Subject: FIELD ACTION UPDATE: PROMPT ACTION REQUIRED: Vector 8500 and 8600MT Battery Cable Clamp Installation
Attachments: SER14-008.pdf; NATT. Vector Clamp Customer Letter.docx; NATT. Vector Clamp Dealer Letter.docx

PROMPT ACTION REQUIRED: Vector 8500 and 8600MT Battery Cable Clamp Installation

SER14-008
03/13/2014

SUBJECT: Tier4 Vector Battery Cable Clamp

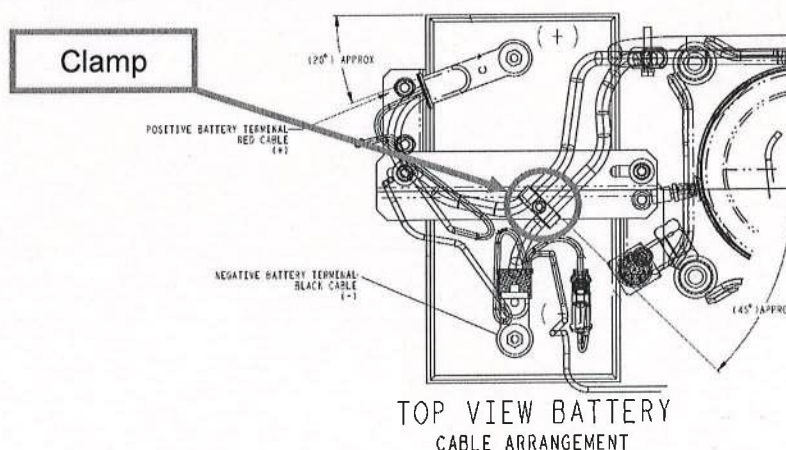
It has been determined that Tier4 Vector units, model 8500 and 8600MT, in the serial number range PAH91333094 through PAT91367875 require an additional battery clamp. Failure to install this battery cable clamp could lead to chaffing of the battery cable.

Insert should be installed in the battery hold down and the clamp should be installed at a 45 degree angle from the compressor side of the battery (see below picture). Torque to 4-5 ft lbs.

QTY	Part Number	Description
1	44-01143-09	Clamp
1	34-00967-40	Bolt
1	34-00945-06	Flat Washer
1	34-00944-06	Lock Washer
